Memorandum

To: Planning and Zoning
Regarding: ZP 21-0536CA/CU
Date: 12/10/20
Project: 14 Strong Street

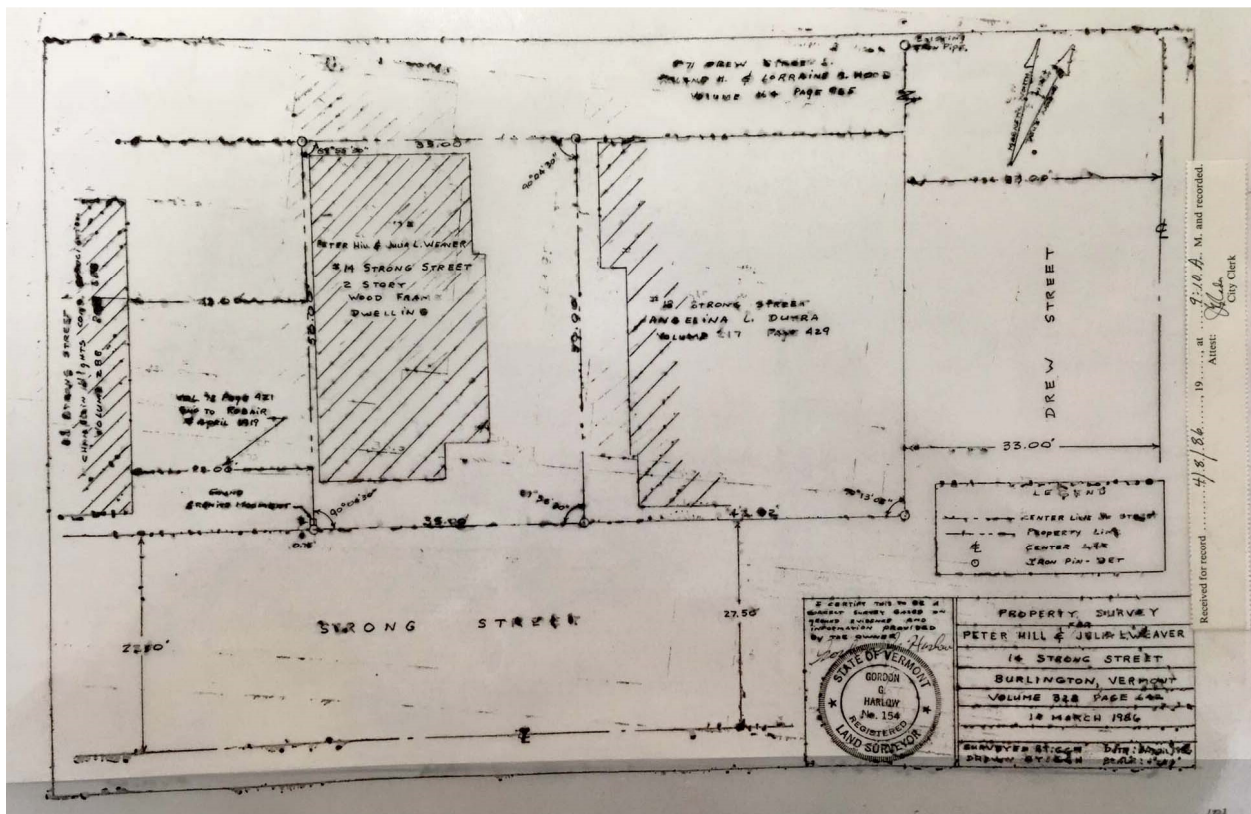
1. Site plan now depicts the two locations of the disputed property boundary. The one shown on Alan's driveway renewal application ZP20-0506CA references a plan from 1983 (ZP20-0914CA). I have also referenced the location of the property line that is represented on a recorded survey (see attached). The matter of the dispute involves the language that is written in the 1919 Deed Volume 72, page 421 which states that the western property line of 14 Strong Street is defined by the following, "SEVENTY-FIVE FEET MORE OR LESS, ON STRONG STREET, AND TWENTY TWO FEET FROM THE EAST WALL OF THE HOUSE ON STRONG STREET (#8)." I have represented both of these dimensions on the site plan accurately, by doing so I want to state clearly that these lines do not overlap and ambiguity currently exists. I have attached Harlow's Original recorded Plat / survey which references this Deed measurement of 22'. I have hired a licensed surveyor to confirm the validity of Harlow's survey and will be able to provide a letter of testimony on Jan. 5th, 2021.

- a. I understand that discrepancies and disagreements to surveys are not issues that this board addresses. This plan accurately represents both property line locations in its site plan and the revised addition does not conflict with either location. Furthermore, a third location has been identified in a more recent deed 04/25/1983 that Bjerke, filed with his commentary 12/02/20 that states "The easterly portion of the lot is subject to a building encroachment to a depth of 3 feet more or less." The site plan presented does not conflict with this assertion of location either and provides a 2'-0" buffer from its description.

2. The revised plans do not include construction within any disputed property line location.
3. The trees between 8 and 14 Strong Street are not noted as being removed nor, is there any intention to do so as we also enjoy the privacy and bird-life these trees provide.

May 1919 Sanborn map showing 8 Strong

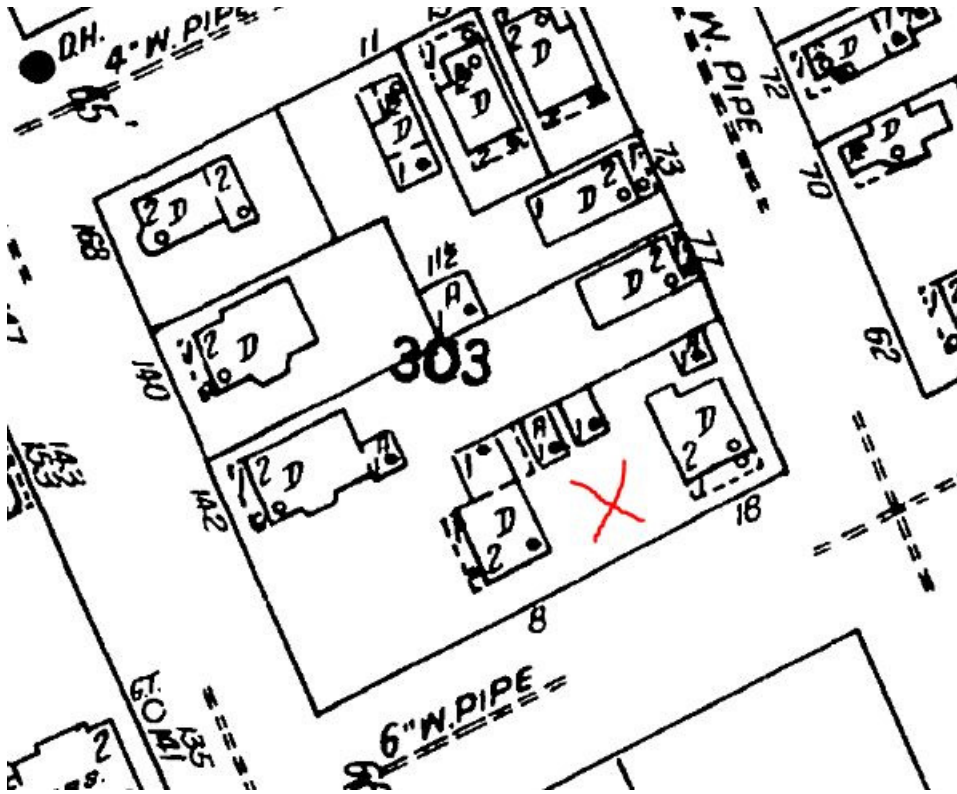
dwelling from which is described in the 1919 Deed Volume 72, page 421. #8 is consistently represented with a "D" for dwelling. Dotted lines on these maps also depict porches. Lastly, the foundation of the front portion of the home is the only one that existed as a basement when the new condominium was constructed and is further evidence of its permanence and location throughout the years. The rear portion has a crawl space beneath it and not a stone foundation based on recorded plat files found on file for the construction drawings of the condominium in 1983.

- According to Bjerke's assertion of the rear building being from which the 22' measurement was taken seems to be incorrect, given that the 1950 Sanborn Fire Insurance map depicts an almost identical outline to the 1919 map but with the inclusion of property line locations and 14 Strong Street dwellings. If the rear building was indeed where the measurement of 22' began, it would place the disputed property line on the eastern side of 14 Strong Street, most of the way through our house. See attached maps.
